GRADING & DRAINAGE PLAN

CONTINENTAL INNS

AS-BUILT/CERTIFICATION

AS BUILT / ENGINEERS CERTIFICATION

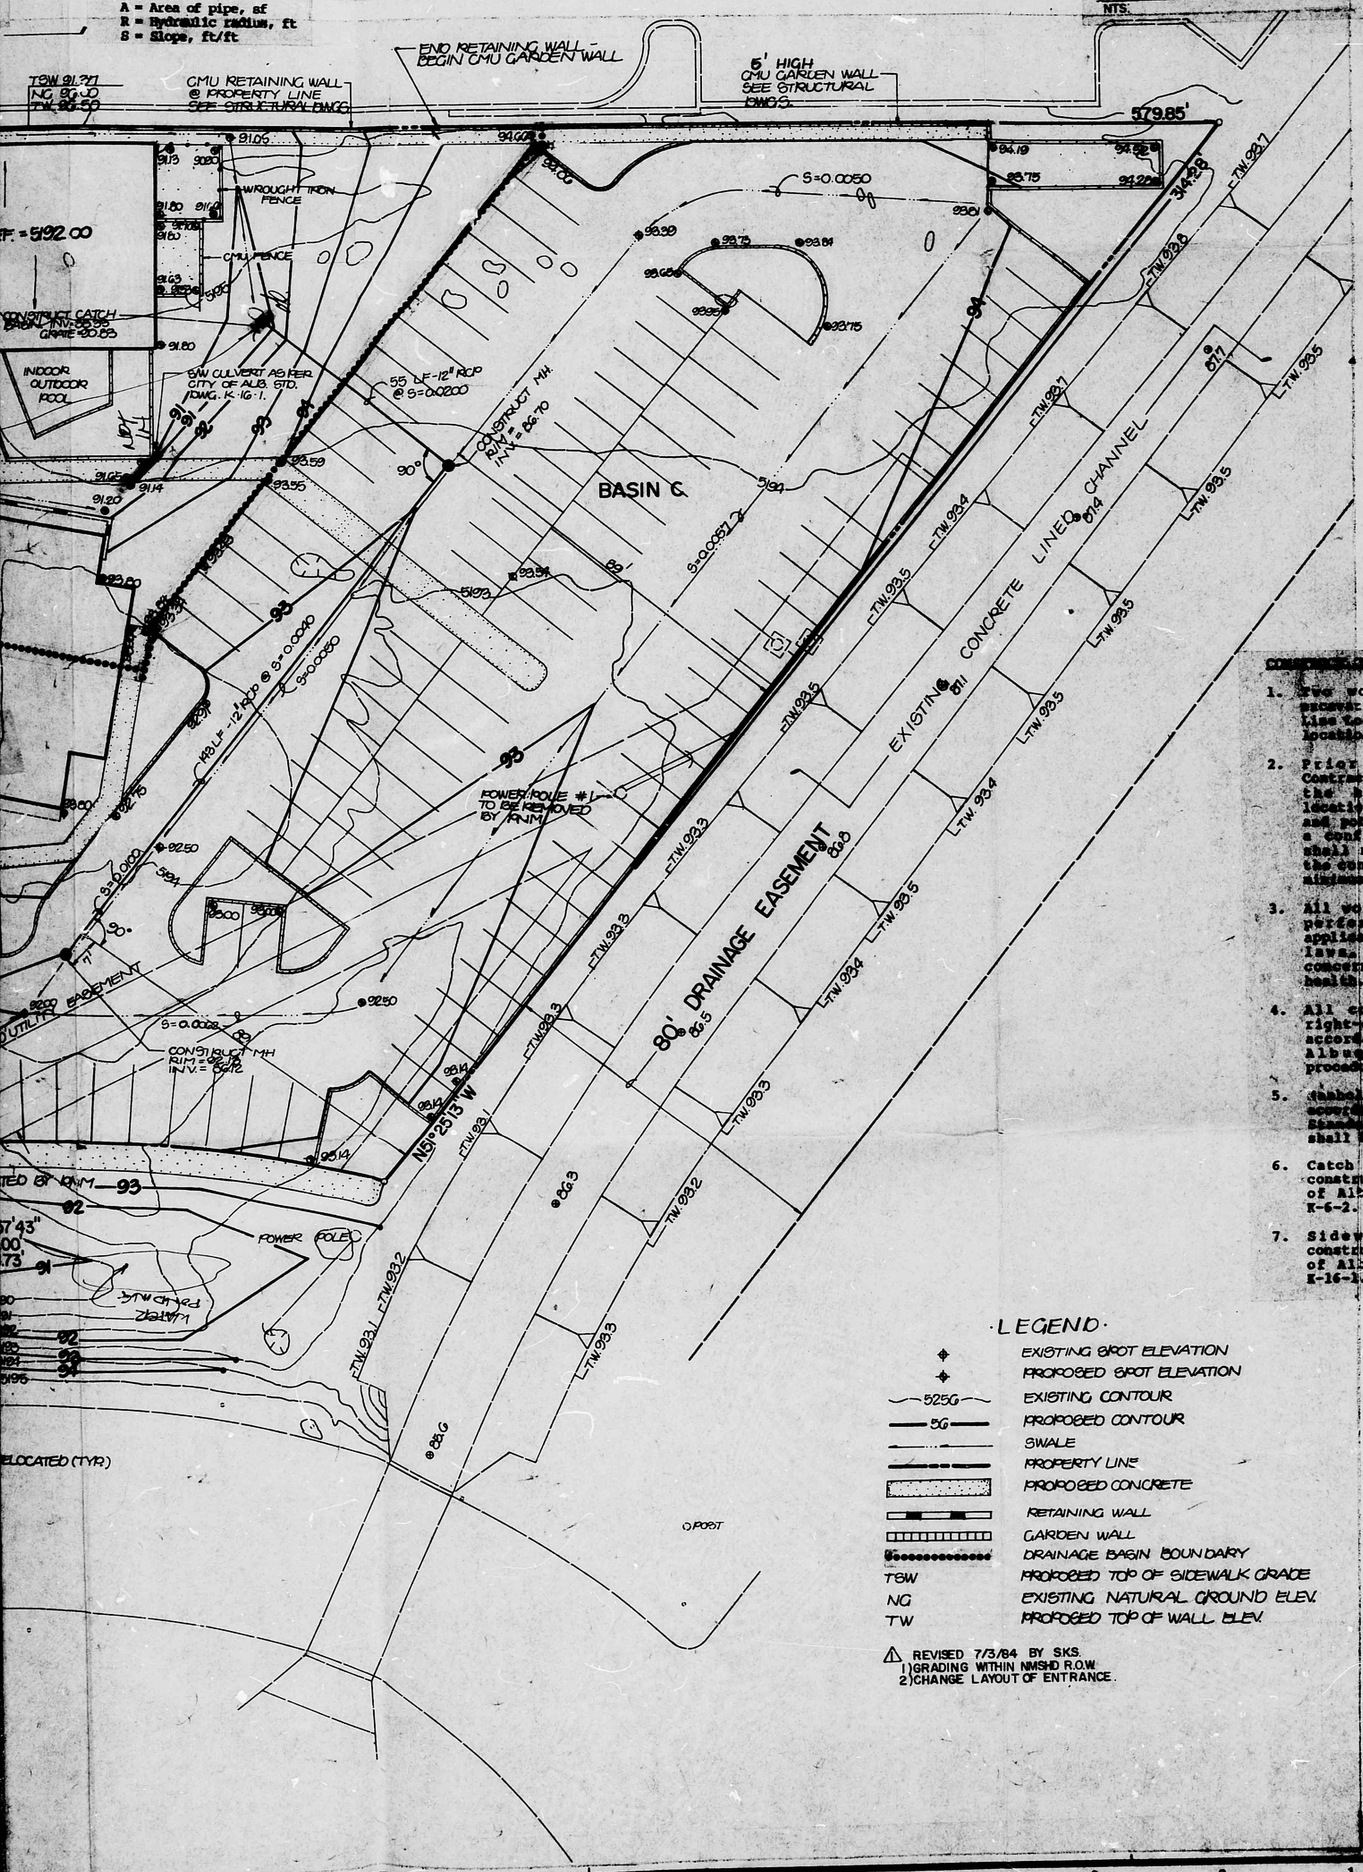
The following field changes were made to the existing Grading & Drainage Plan designed by Thomas T. Mann., Jr.

1. The 12" C.M.P. drainline running from the north side of the entrance drive to the south side of the drive has been eliminated as well as the center island in the entrance driveway.
2. All drainage pipe has been changed from R.C.P. to P.V.C.
3. All roof drainage was designed to run overland to the catch basins but was field changed to be piped underground directly to the storm drain.
4. The direction of flow in the sidewalk channel on the east property line has been reversed so that flow that was going to Basin B is now going to Basin A thus changing the size of both basins respectively and the Q_{100} flow to each catch basin, but the developed total Q_{100} leaving the site is virtually the same.

There are several other very minor onsite changes which did not have any effect on the total Q_{100} leaving the site.

AS BUILT CONDITIONS:

CN = 92
% Impervious = 90%
Area = 130,700 SF or 3.0 acres
C = 0.86
= 4.80 in./hr.
Q_{100} = 12.4 c.f.s.
V_{100} 15,790 CF
